Technical Service Bulletin

Subject: A/C BLOWS WARM AIR DUE TO REFRIGERANT LEAK FROM CONDENSER	Bulletin No.: 07-001/18
	Last Issued: 04/19/2018

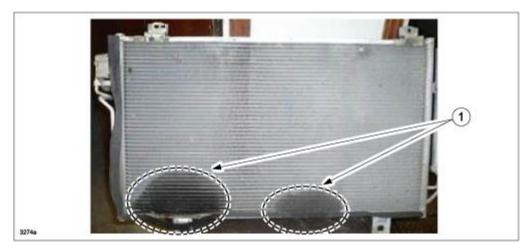
Some customers may complain about warm air from the climate control vents when the air conditioner is ON. This may be caused by condenser corrosion, causing a refrigerant leak.

The manufacturer of the condenser has been changed and the configuration of the condenser tube has been improved.

REPLACEMENT PARTS LOCATION

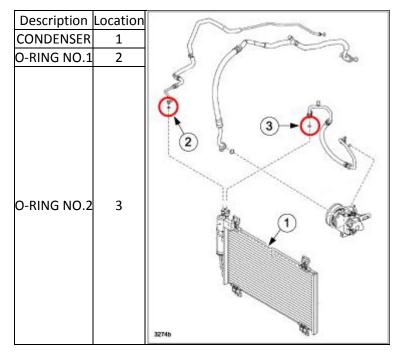
- 1. Verify the customer concern.
- 2. Visually inspect the condenser for A/C refrigerant leak.
 - Is there a visible trace of A/C refrigerant leaking at location (1)?

3. Use a dealer supplied UV leak detection tool. Is there a trace of fluorescent liquid at location (1)?

4. Replace the condenser according to the instructions on MGSS online (CONDENSER REMOVAL/INSTALLATION [SKYACTIV-G 2.0]).
5. Verify the repair.
